CNRO-2005-00030

SUBJECT: Request for Alternative RBS-PT-001  
Response to NRC Request for Additional information

River Bend Station  
Docket No. 50-458  
License No. NPF-47

**RESPONSE TO THE NRC'S  
REQUEST FOR ADDITIONAL INFORMATION  
REGARDING REQUEST FOR ALTERNATIVE RBS-PT-001**

**FIGURE 1**  
**CMS Loop A**

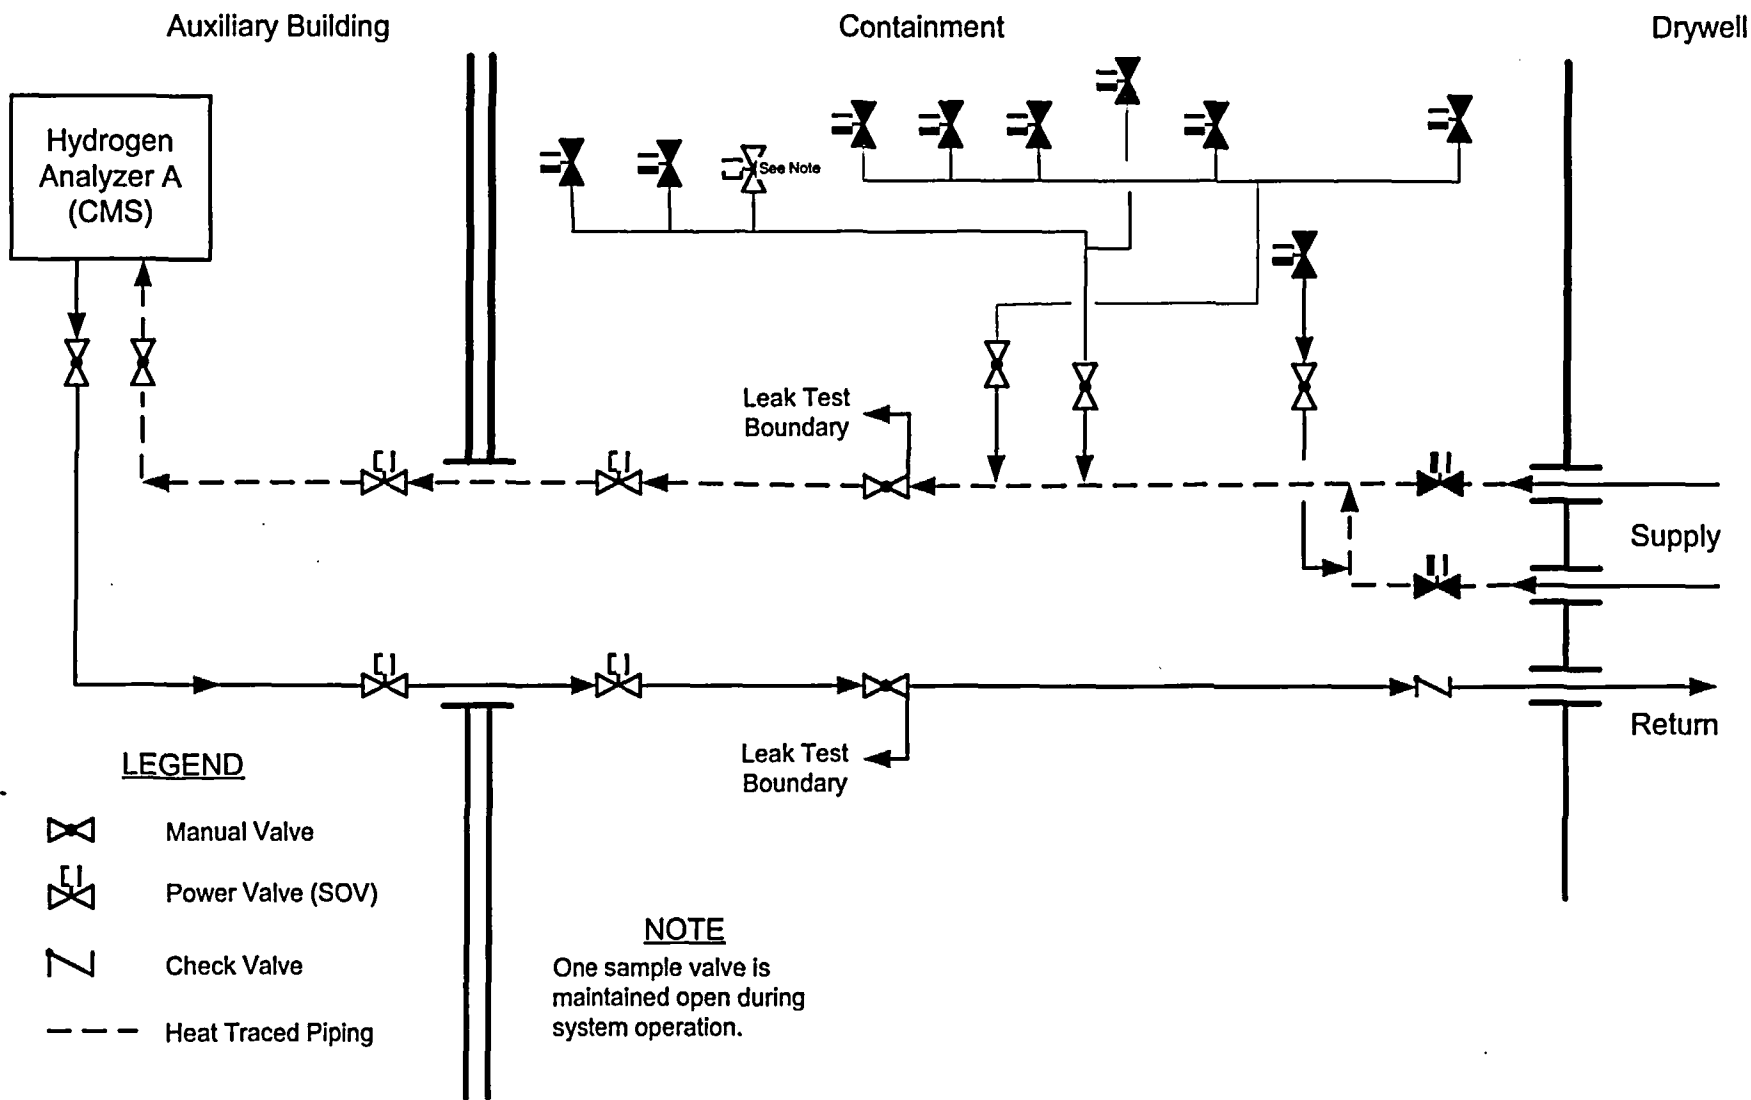
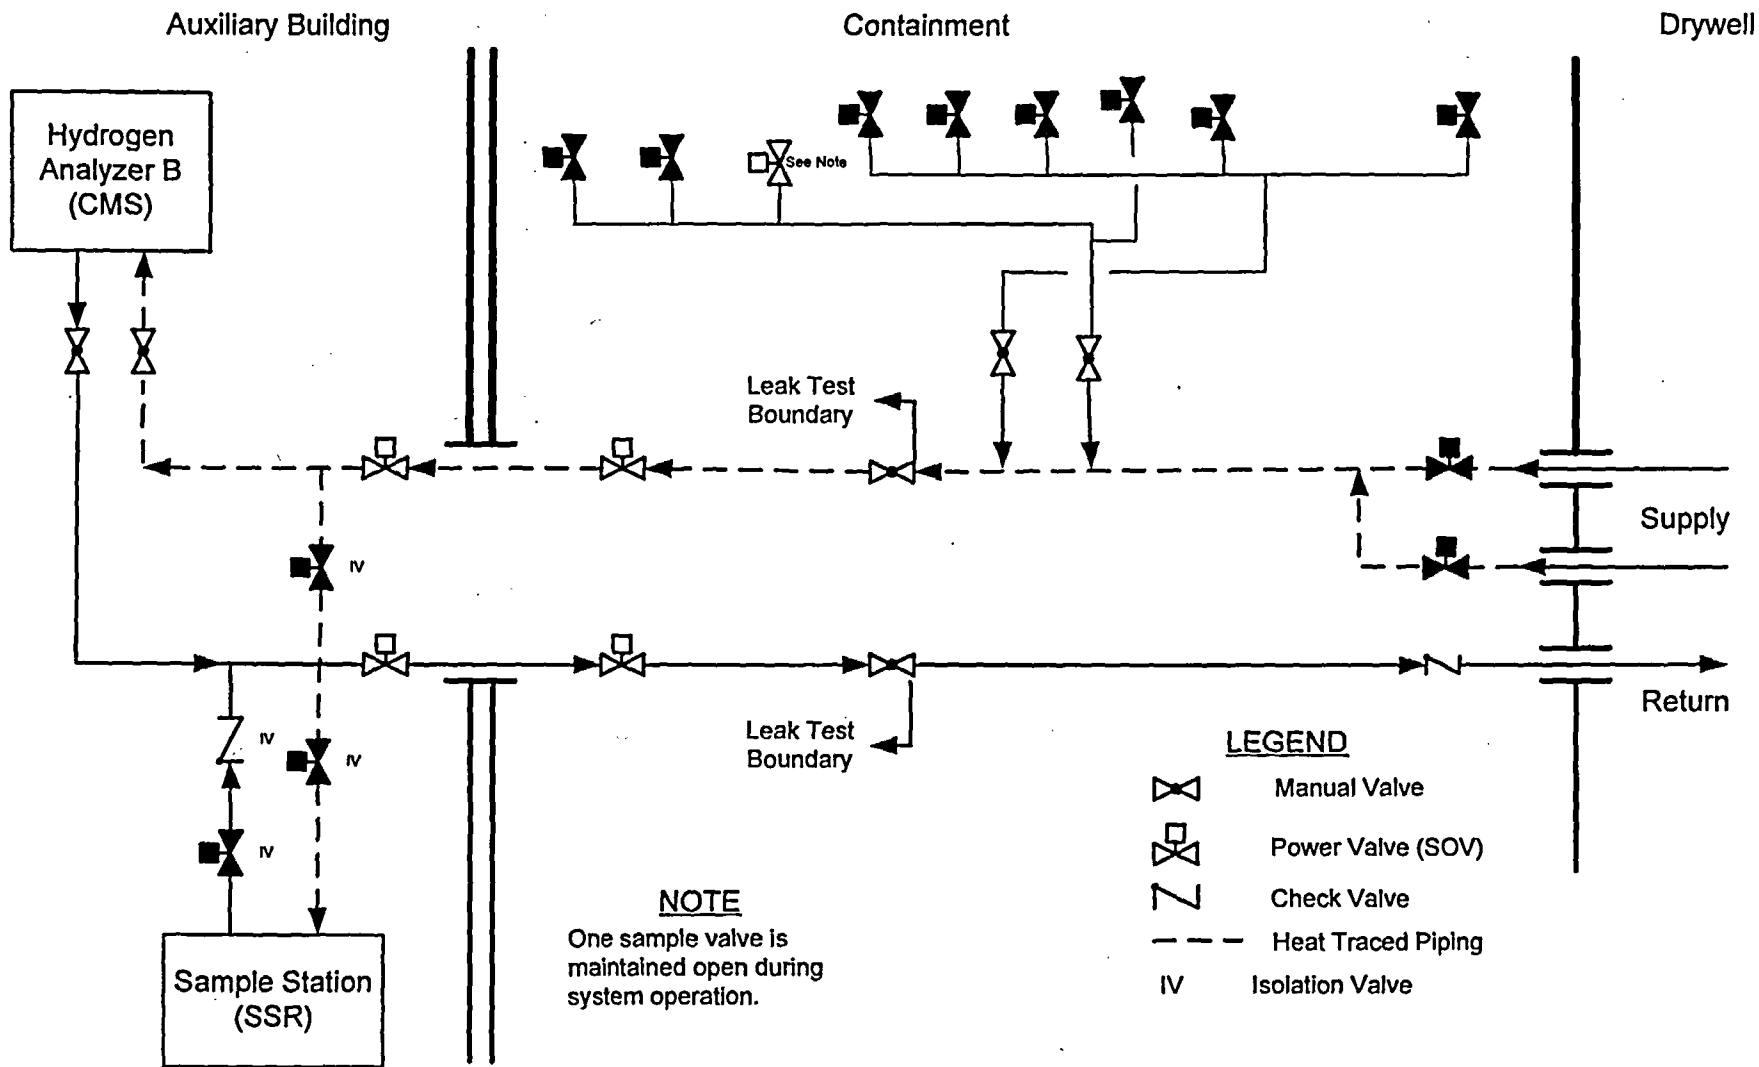
Describe how the system leak test will be performed including how the leakage will be measured.

*The integrity of the Containment Atmosphere Monitoring System (CMS) piping and Reactor Plant Sampling System (SSR) piping will be verified and monitored by performing leakage rate testing in accordance with the River Bend Station (RBS) Leakage Reduction and Monitoring Program. This testing encompasses the supply and return pneumatic tubing/piping and the hydrogen analyzer components between two manual isolation valves (one each in the supply and return pneumatic lines for the analyzer) located within containment (see Figures 1 and 2 of RBS-PT-001). System piping will be pressurized to  $\geq 8$  psi and held for 15 minutes.*
